**AWS D1.1 Interpretation**

**Subject:** Prequalified Joints  
**Code Edition:** D1.1-94  
**Code Provision:** Figure 2.4  
**AWS Log:** 2.28

**Joint A**

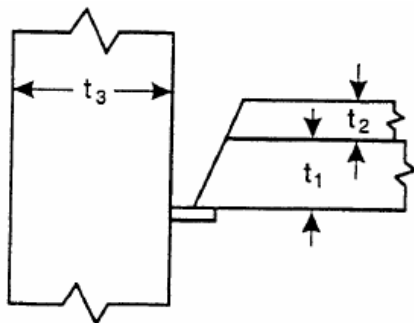
**Inquiry:** Are the joint details (see figure) prequalified according to D1.1-94, Figure 2.4?

Note: All dimensions meet requirements of Figure 2.4, TC-U4a-X, except  $T_1 = t_1 + t_2$

**Response:** Yes.

**Joint B**

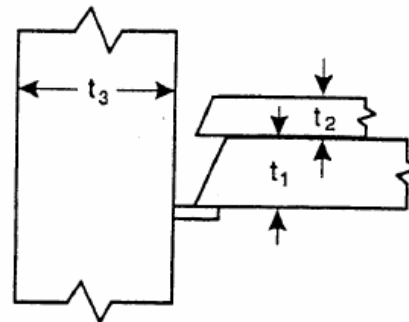
Note: After CJP groove weld  $t_1$  to  $t_3$  is complete, then plate  $t_2$  is added and welded to  $t_3$ . Dimensions of both CJP welds meet requirements of TC-U4a-X.
